Service Bulletin

MEB02-12

MAIN LANDING GEAR TORQUE LINK INSPECTION

Main Landing Gear Torque Link Washer Inspection/Replacement
Figure 1 (Sheet 1)

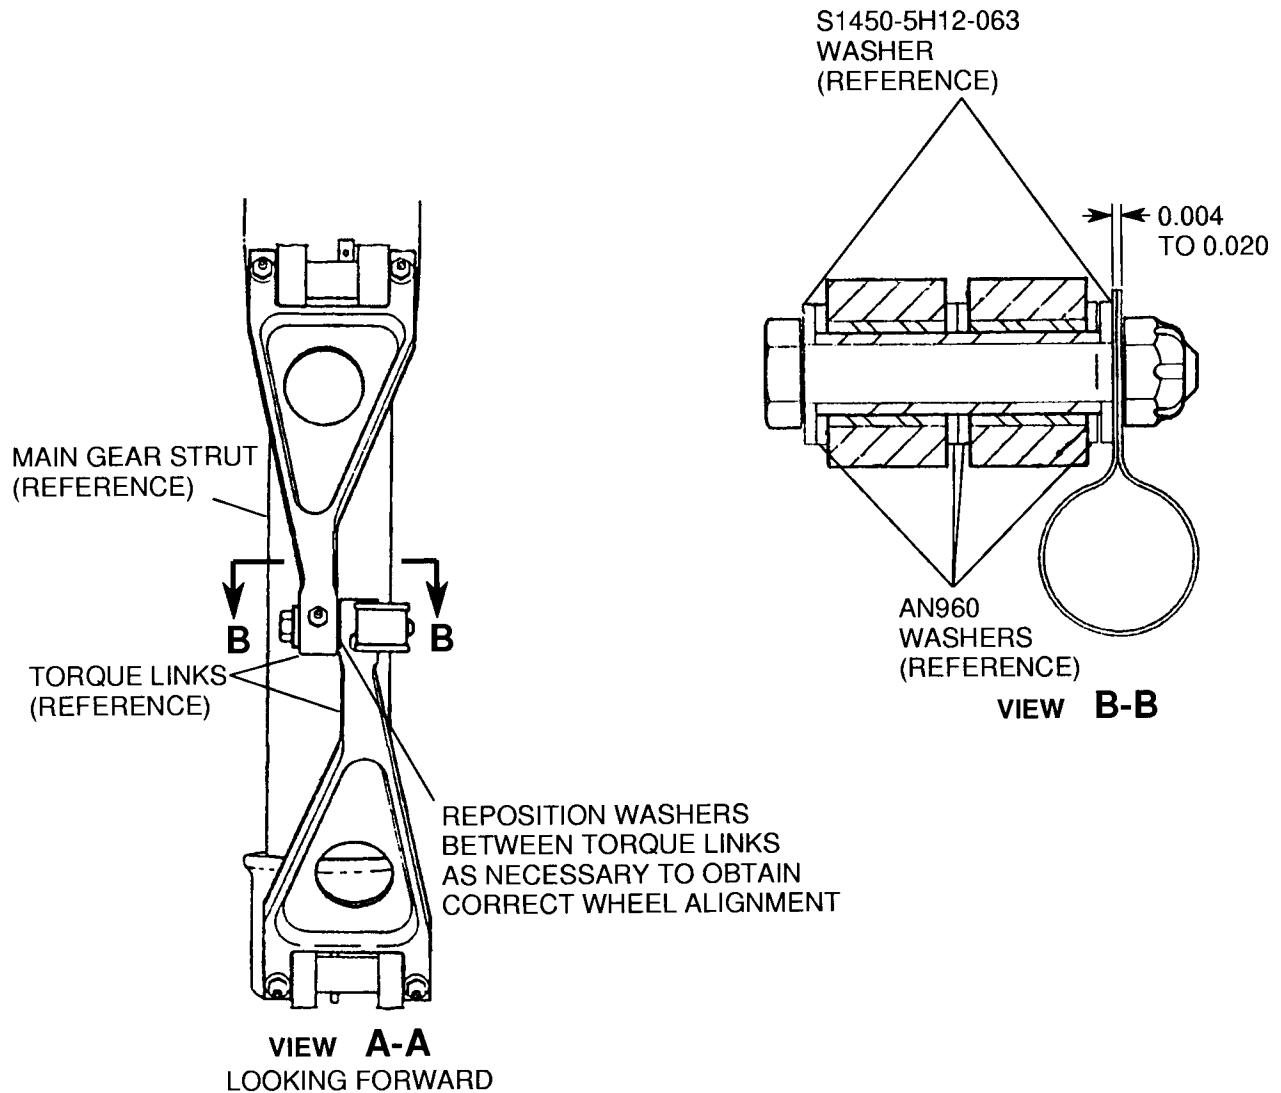
1. Jack the airplane in accordance with the Service Manual.
2. (Refer to Figure 1, Detail A.) Look at the main landing gear upper and lower torque links and record the number of washers installed at each location.

- B. If the outside diameter of the washer(s) is 0.75, keep the washer(s) for reinstallation. Go to Step 5.
5. (Refer to Figure 1, Detail A.) Reassemble the torque link with the parts below.

- B. (Refer to Figure 1, Detail A.) Install one new MS17825-5 nut and one new S1450-5H12-063 washer or kept S1450-5H12-063, 5045018-1 or 5045018-2 washer under the brake line clamp as shown.

- (1) Tighten the nut and check for proper cotter pin hole alignment and side play of the torque link assemblies.
 - (2) (Refer to Figure 1, View B-B.) Maintain a 0.004 inch (minimum) to 0.020 inch (maximum) side play of the torque link assemblies.

- (3) Make sure that the spacer washers are centered on the bushing.
 - (4) Torque the nut 100 to 140 inch-pounds.
 - C. (Refer to Figure 1, Detail A.) Install one new MS24665-153 cotter pin.

6. Do Steps 2 through 5 for the opposite side.
7. Remove the airplane from the jacks in accordance with the Service Manual.
8. (Refer to Figure 1, View A-A.) Check for proper toe-out alignment. Reposition AN960 washers as necessary to obtain proper wheel alignment. (Refer to applicable sections of the Service Manual.)

NOTE 1: RECORD NUMBER OF WASHERS AT EACH LOCATION BEFORE DISASSEMBLY AND REINSTALL SAME NUMBER OF WASHERS UPON REASSEMBLY.

NOTE 2: REPLACE ANY WASHERS AT THESE LOCATIONS THAT HAVE AN OUTSIDE DIAMETER OF LESS THAN 0.75 INCH WITH S1450-5H12-063 WASHERS.
